BIG BOSS WASHING LTD

Aptech Industrial Park, 30, Sarabo, Kashimpur, Gazipur

21st September 2021

Observations: Washing Building

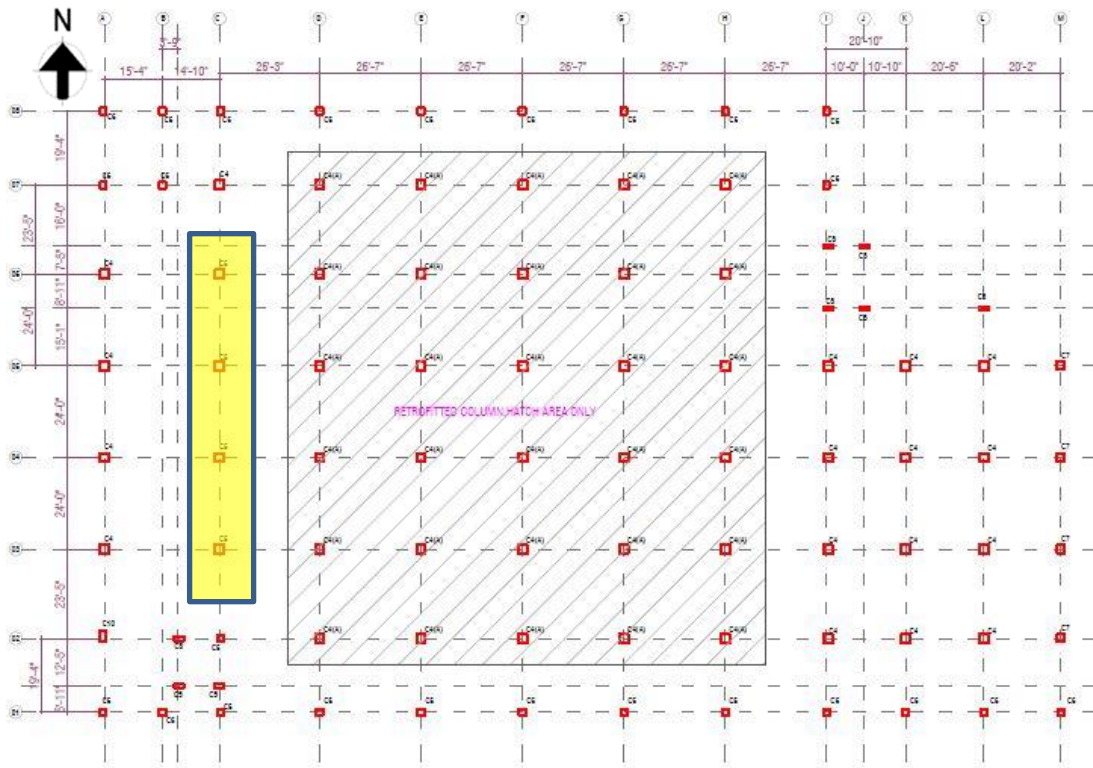
13 sets of concrete cylinder test reports for were available. The concrete sample locations were unknown, mix ration of different structural members were not mentioned, minimum number of sample requirement did not comply with BNBC. Also, design strength was unknown. Therefore, minimum concrete strength has been considered for capacity calculation. The factory engineer is required to determine in-situ concrete strength of the building.

Column grid, floor, concrete mix ration are not mentioned

Marginally stressed column/foundation layout

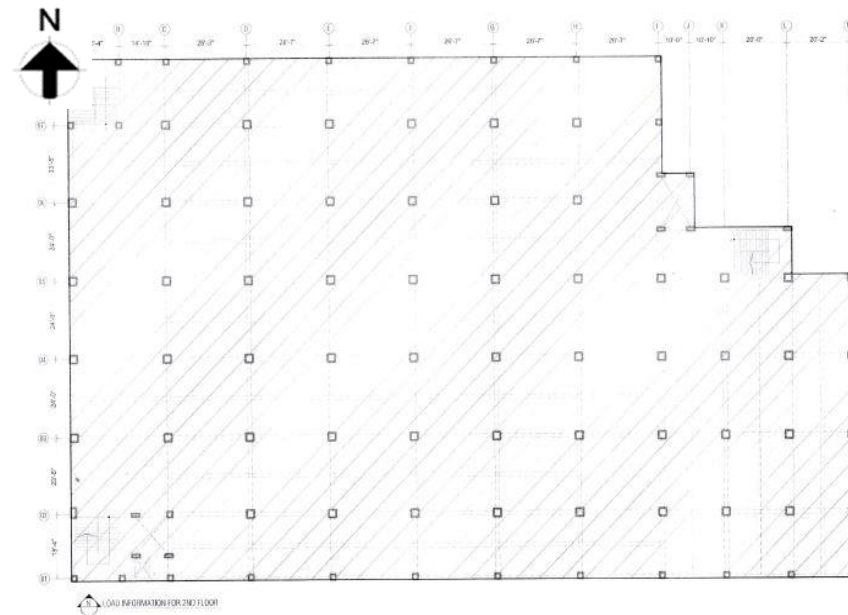
Live load (storage) at highlighted area

Cursory calculation shows that stress in marked columns and foundations marginally exceeds the normal design limit considering the floor live load 4 kPa for typical floors (as per load plan) and 6 kPa for storage areas only. Factory engineer is required to review the design, loads and column/foundation stresses based on in-situ concrete strength.

Item No.	Observation	Recommended Action Plan	Recommended Timeline
01	Stress in column and foundation marginally exceeds normal design limit (Washing Building)	Factory engineer is required to review the design, load, column and foundation stresses based on in-situ concrete strength.	6-weeks
02	Stress in column and foundation marginally exceeds normal design limit (Washing Building)	Verify in-situ concrete strength by take minimum 4 concrete cores (100mm diameter) from lower tier of the buildings.	6-weeks
03	Stress in column and foundation marginally exceeds normal design limit (Washing Building)	Implement any remediation work if required.	6-months
04	Design Report needs to be prepared (Washing Building)	Factory engineer is required to prepare the Design Report in compliance with section 1.9.1.1 (part-6, BNBC).	6-weeks
05	Design Report needs to be prepared (Washing Building)	Implement any remediation work if required	6-months

Typical beam layout

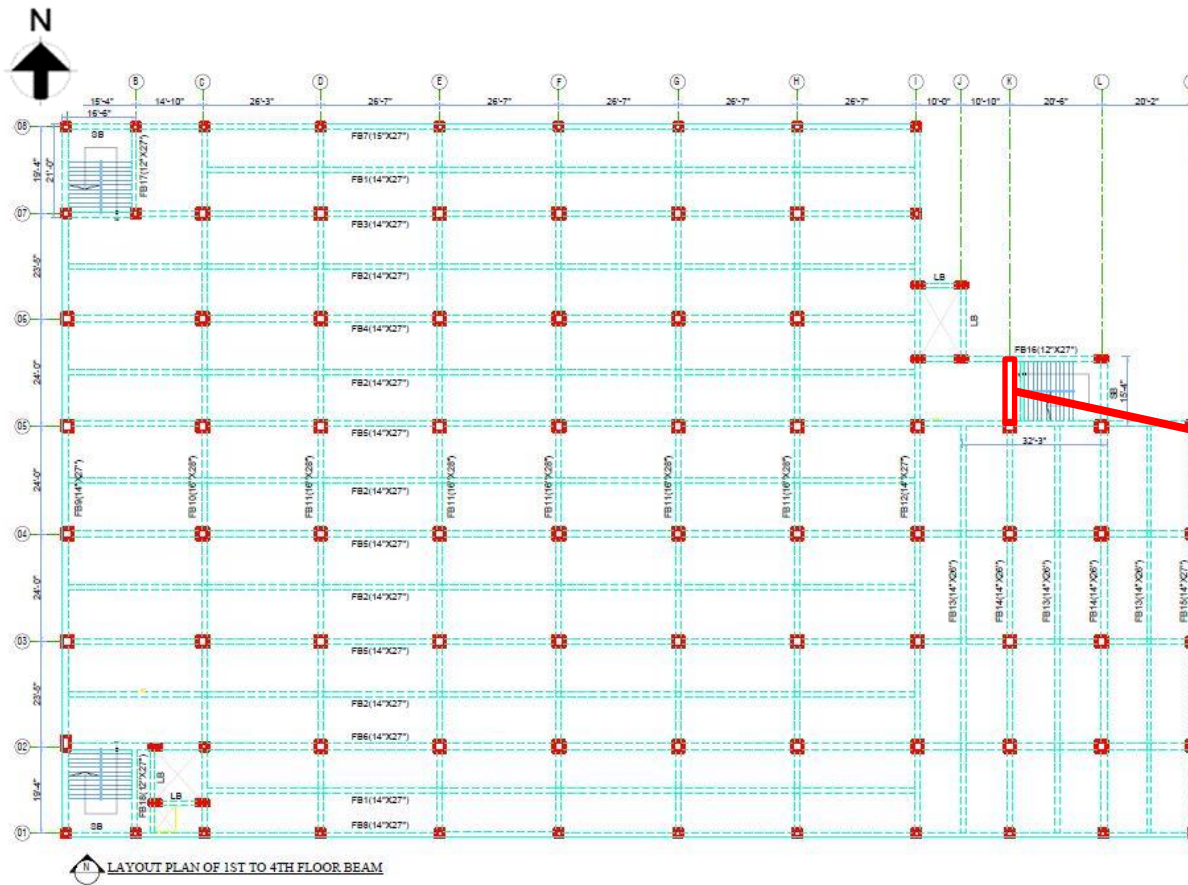
Beam found but not shown in layout

Beam at highlighted location was not shown in beam layout but found at site (every floor). Factory engineer is required to update the as-built structural drawing.
